Subject: Additional background info for today's telecon

Questions for which National Labs' Assistance Would be Beneficial

Macondo MC 252

Schematic AS DRILLED, 6/21/2011
 SNL093-014801

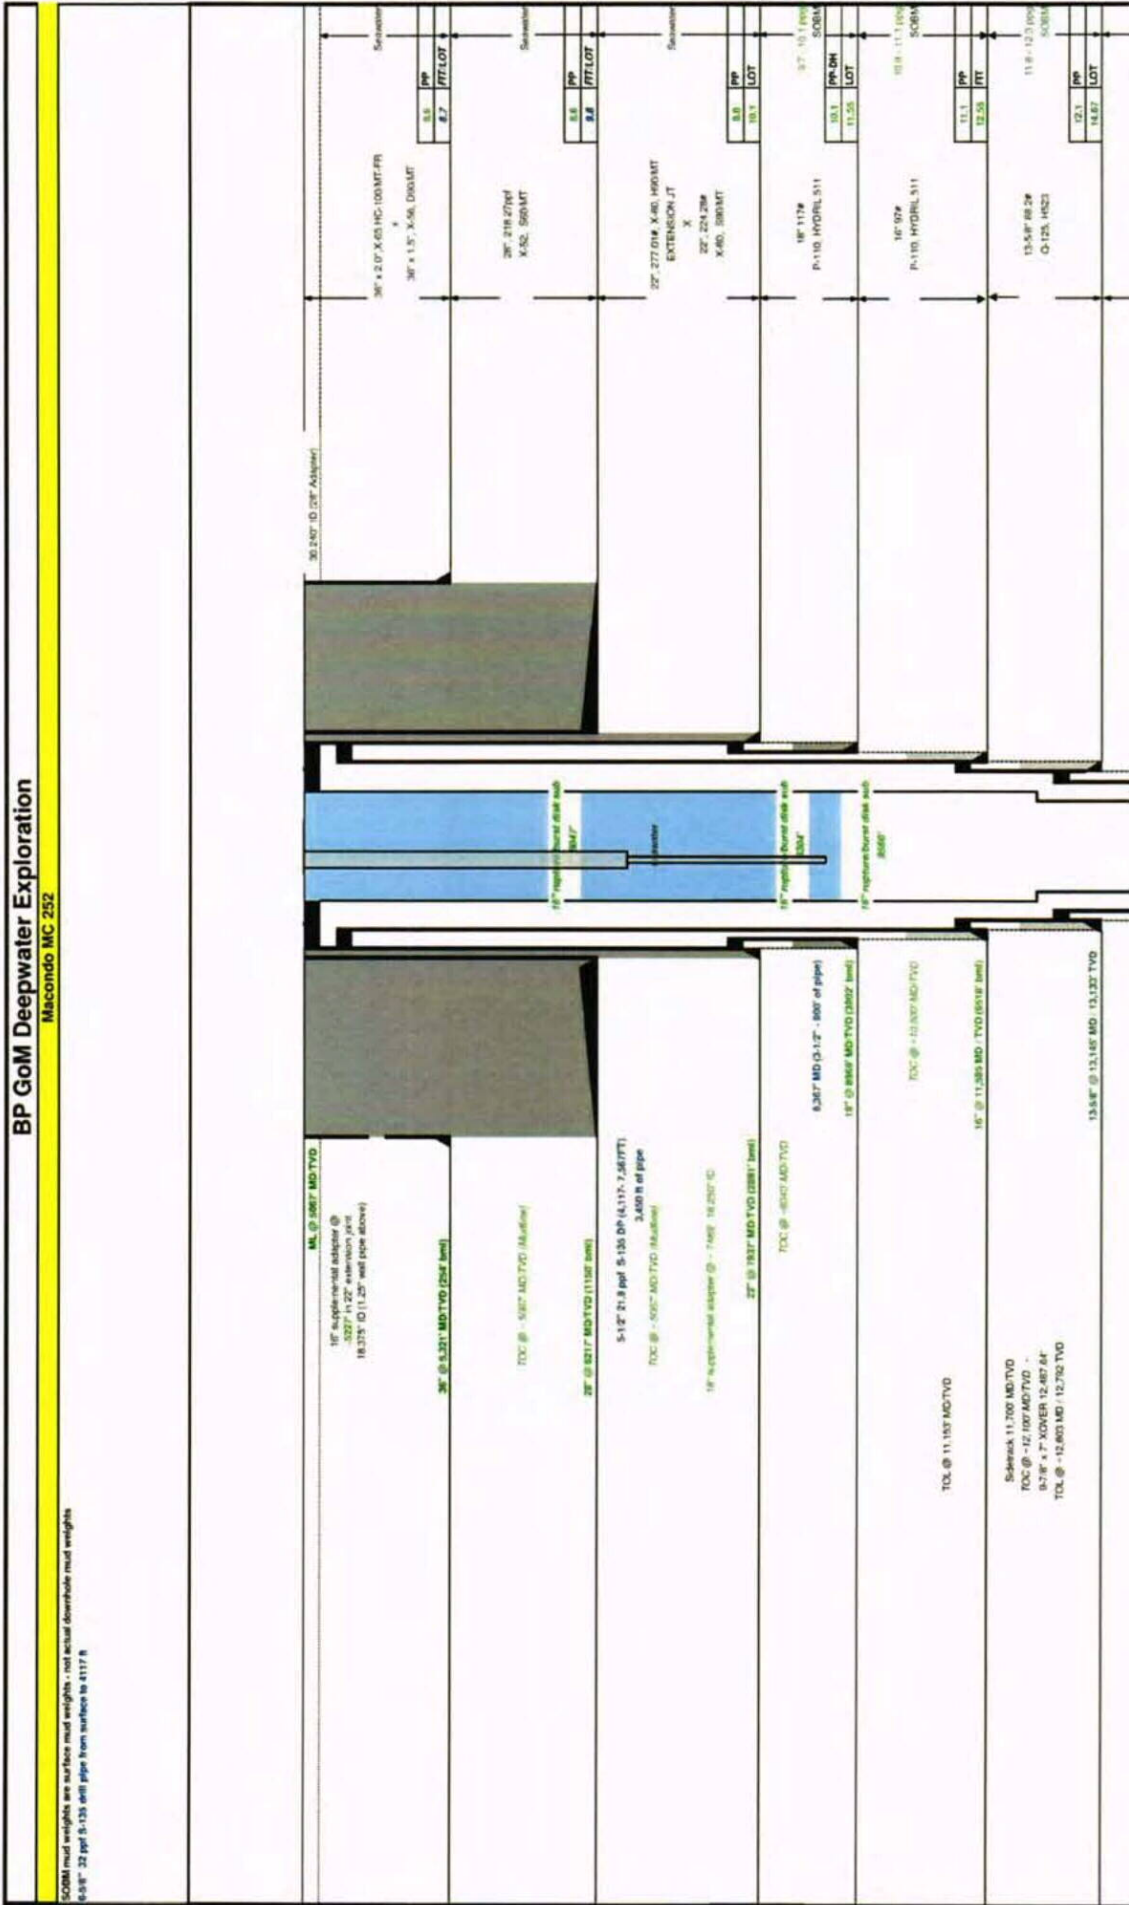
To reiterate, I am with the DOE team under Tom Hunter looking into the oil spill. We are having difficulty being clear as to the configuration of the well below the mud line. Would it be possible to provide the following info, either as text or better as a simple pencil sketch on a sheet of paper that can be scanned and sent to Tom ("Hunter, Tom" <tohunte@sandia.gov>) for onward distribution:

Sketch of well, showing:

- Nesting of casing strings
- Depth to bottom of each string (any liners ?)
- Height of cement above shoe in each case (any intervals with csg but no cement between csg and formation ?)
- Any perfs or open hole
- Position of cement plugs inside csg
- Any pressure taps near csg hanger or wellhead into inter-casing spaces

Attached please find the as drilled wellbore sketch for the MC252 #1 well. It shows the nesting of casing strings with the casing shoe depths indicated in both MD and TVD RKB. Kelly bushing and drill floor are used equivalently to reference that datum 75 feet above mean sea level. Liner tops are indicated with their depth, so that you can distinguish liners from strings going all the way to surface. Cement tops also are indicated schematically. The casing was not perforated during well construction. However, the TD of the well is at 18360 ft MDRKB and the 7" shoe is at 18304 ft MDRKB. No cement plugs had been set above the float collar at 18,115 ft MDRKB at the time well control was lost.
